DART AEROSPACE LTD		Work Order:	94346
Description: Crosstube Assembly (205/212 High Aft)		Part Number:	D212-664-241
Inspection Dwg: D212-664-241 Rev: D		Page 1 of 2

DRAWING NO. D212-664-241	TITLE CROSSTUBE ASSY (205/212 HI AFT)	REV. D	DART AEROSPACE LTD ENGINEERING ORDER		D.E.O. NO. D212-664-241-D-1	SHEET NO. SHEET 1 OF 2	SCALE NTS
DRAWN	CHECKED	MFG. APPR.	APPROVED	DE APPR.			
DATE 11.04.07	DATE 11.04.11	DATE 11.04.12	DATE 11/04/12	DATE 11.04.12

ADD AN INSPECTION WINDOW TO UNDERSIDE OF CROSSTUBE.

REPLACE MAGNOBOND WITH PROSEAL.

**D212-664-241/-241B
ASSEMBLY DETAIL**

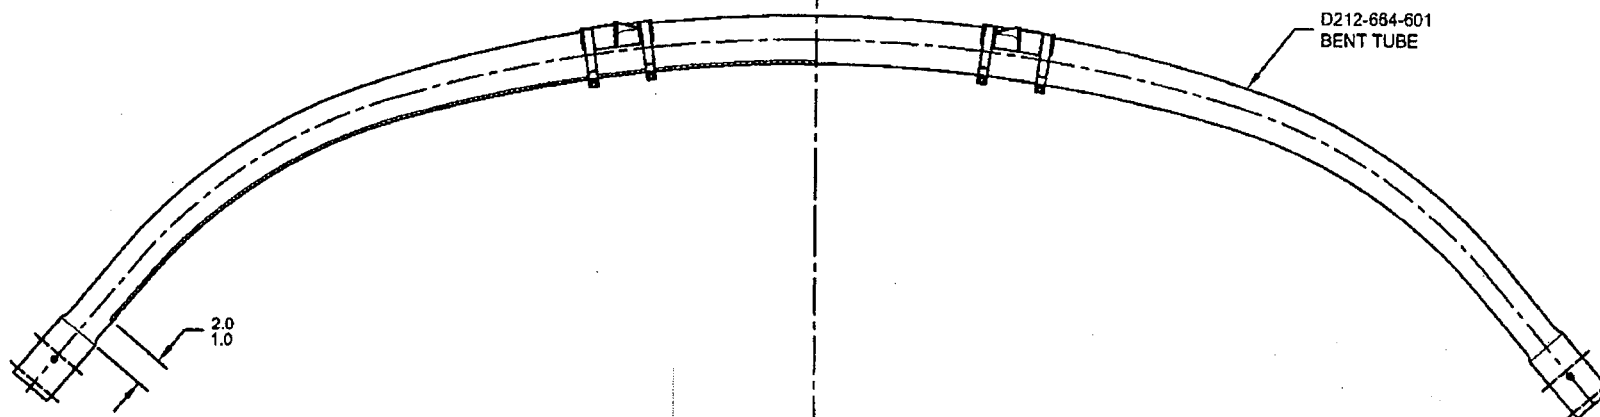
NOTES 2 OF SHEET 1 IS AMENDED AS FOLLOWS:

MASK AREA PRIOR TO PAINTING,
REMOVE MASKING AFTER PAINT
AND APPLY CLEAR COAT

- 2) FINISH: CHEMICAL CONVERSION COAT PER DART QSI 005 4.1
PRIME INSIDE AND OUTSIDE PER DART QSI 005 4.2
MASK UNDERSIDE OF CROSSTUBE AS SHOWN (HATCHED AREA) AND
PAINT OUTSIDE PER DART QSI 005 4.2
REMOVE MASKING AND APPLY CLEAR COAT
